[Docket No. FAA-2012-0182; Directorate Identifier 2012-CE-005-AD; Amendment 39-16958; AD 2012-03-52]

Airworthiness Directives; Mooney Aviation Company, Inc. (Mooney) Airplanes

ACTION: Final rule; request for comments.

Figure 1

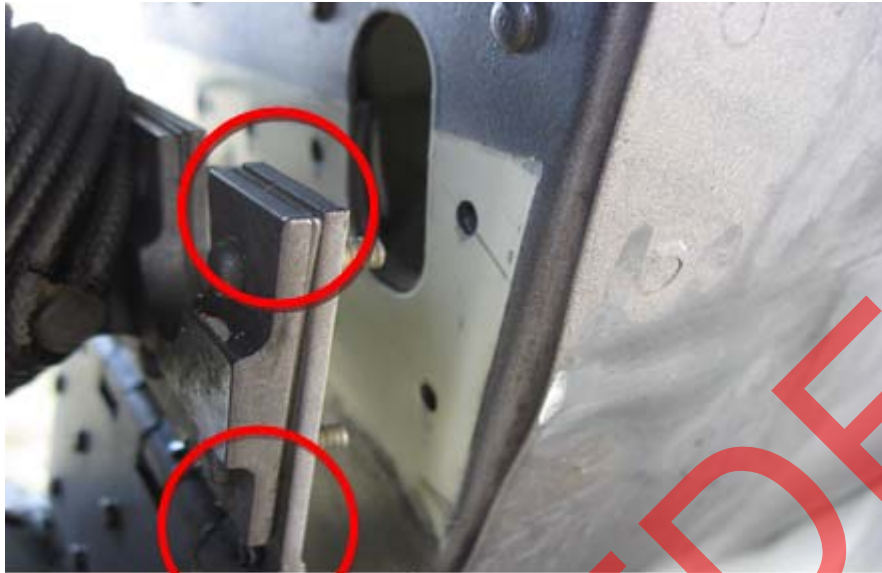
Mooney inspected several other aircraft and found that on one airplane the filler plate was incorrectly installed. The filler plate was not correctly installed between the aft side of the hinge and the bulkhead. Instead, the filler plate was located on the forward side of the hinge between the hinge and trim fitting. It was then noted the incident aircraft had the same issue, as shown in the upper circle of figure 1.

Because the hinge has a lip on the bottom, on the side toward the bulkhead (as shown in the bottom circle of figure 1), if the filler plate is not installed correctly, the hinge will not fit flush against the bulkhead, the Huck Bolt fasteners will not fit perpendicular to the bulkhead, and the

collars will not swage properly. The condition also causes excessive tension pre-load on the Huck Bolts.

Before further flight after receipt of this AD, inspect the trim fitting, hinge, and filler plate of the tail pitch trim assembly for correct positioning and proper attachment; and also inspect that the Huck

Bolt fasteners are properly secured following Mooney Aviation Company, Inc. Service Bulletin No. M20-313, dated February 7, 2012.

If during the inspection required in paragraph (g) of this AD you find incorrect positioning or improper attachment of the trim fitting, hinge, and filler plate of the tail pitch trim assembly; and/or you find loose or improperly installed Huck Bolt fasteners, before further flight, contact Mooney for FAA-approved repair instructions and perform the repair. Use the contact information found in paragraph (n)(2) of this AD.
